PREPARED FOR THE PLAN COMMISSION

**Project Address:** 3734 Speedway Road (District 5 – Ald. Vidaver)  
**Application Type:** Demolition Permit and Conditional Use  
**Legistar File ID #:** [69785](#) & [69786](#)  
**Prepared By:** Chris Wells, Planning Division  
Report Includes Comments from other City Agencies, as noted  
**Reviewed By:** Heather Stouder, AICP, Planning Division Director  
Kevin Firchow, AICP, Principal Planner

**Proposal Summary:** The applicant proposes to demolish a one-story commercial building to construct a four-story, mixed-use building with 816 square-feet of commercial space and 31 apartments.

**Image 1 – An excerpt of the map of the Mineral Point/Speedy Neighborhood Commercial Node from the Hoyt Park Area Neighborhood Plan**

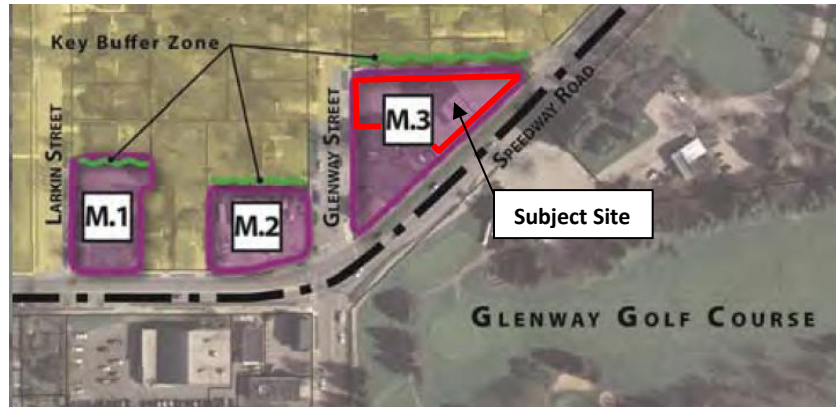
While Staff believe that the proposal is consistent with the Hoyt Plan's recommended land uses, the proposed building exceeds the Plan's three-story maximum height recommendation. Regarding the bulk transition, the Plan labels this as a "Key Buffer Zone" (see Image 1) and recommends to "maintain single-family residential scale along adjoining streets and property edges." From a Zoning code standpoint, staff notes that: 1) the proposal meets the Zoning Code's requirements for *Side Yard Height Transition to Residential Districts* (MGO 28.064(3)(d)) along the entire northern property line (see further discussion below); and 2) the six-foot building setback along this property line satisfies the Zoning Code. Considering the approximate 10-foot drop in grade, staff notes that the difference in height between the proposed and existing structures is greater on the eastern, Speedway Road side of the site where the building is four story in height, compared to on the western Glenway Street side, where the height is three stories.

**Image 2 – The Bulk Transition of the Proposed Building as seen on the Northeast Elevation (left) and West Elevation (right)**

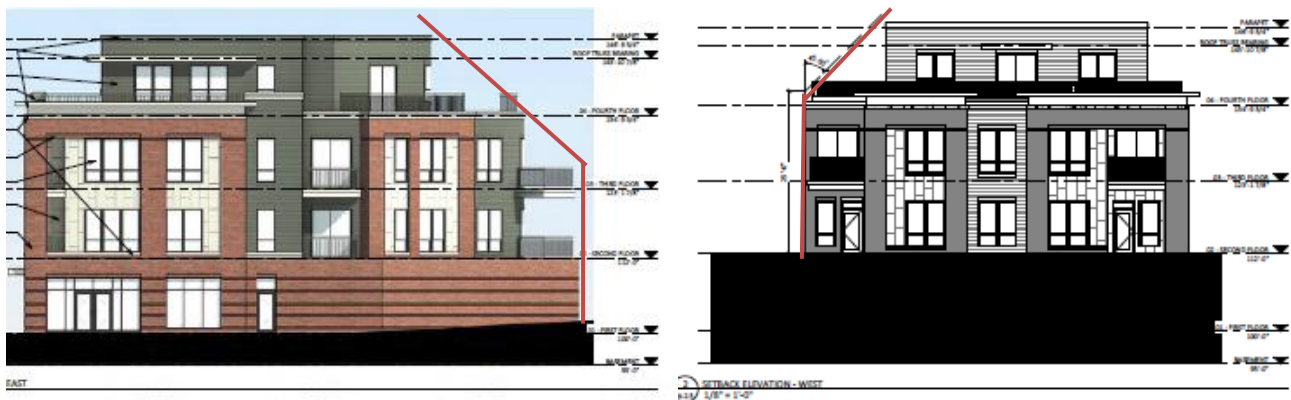
Staff also note that the proposal satisfies the side yard height transition to the residential district to the north, in this case the parcels located at 321 Glenway Street and 320 Waverly Place which are both zoned Traditional Residential – Consistent 2 (TR-C2) District and contain one- to one-and-a-half-story single-family residences. As MGO §28.064(3)(d) reads, “Where the NMX District abuts a residential district at the rear or side lot line, building height at the rear setback line (in this case, 6 feet) shall not exceed two (2) stories/twenty-five (25) feet. From this point, building height may increase at a ratio of one foot of rise to one foot of horizontal distance away from the property line, (a 45° angle) up to the maximum allowed height. Transitions exceeding this height and/or ratio limitation require conditional use.” Examining the submitted elevations, both the west elevation as well as the northeast elevation show the building’s compliance along the northern property line (see the transition requirement indicated by the red lines in the images below).
